IN THE DRAWINGS

REMARKS

FIG. 2C

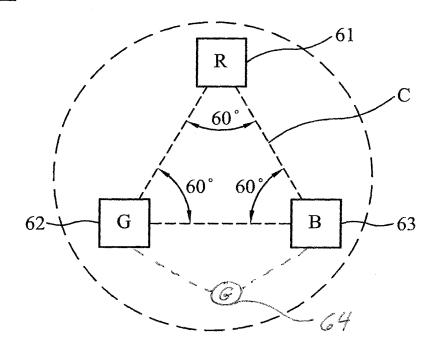
FIG. 2C is amended to add the adjacent light emitting diode 64.

FIG. 3A

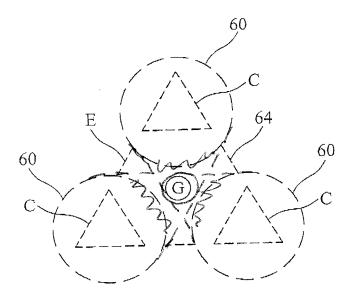
FIG. 3A is amended to modify lines to illustrate the grouping of the first, second,

and third light emitting diode (61, 62, 63) and the adjacent light emitting diode.

FIG. 3B

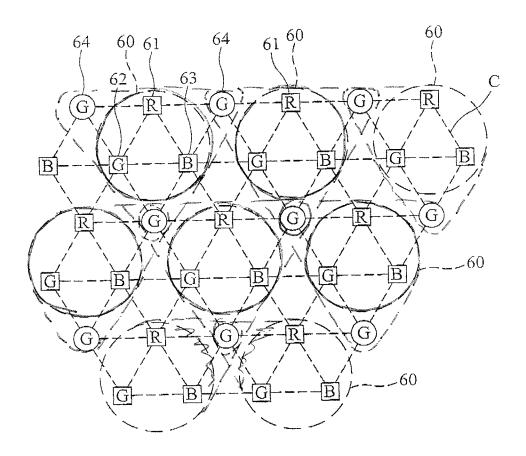
FIG. 3B is amended to modify lines to illustrate the grouping of the first, second,

and third light emitting diode (61, 62, 63) and adjacent light emitting diodes in a cell

structure.
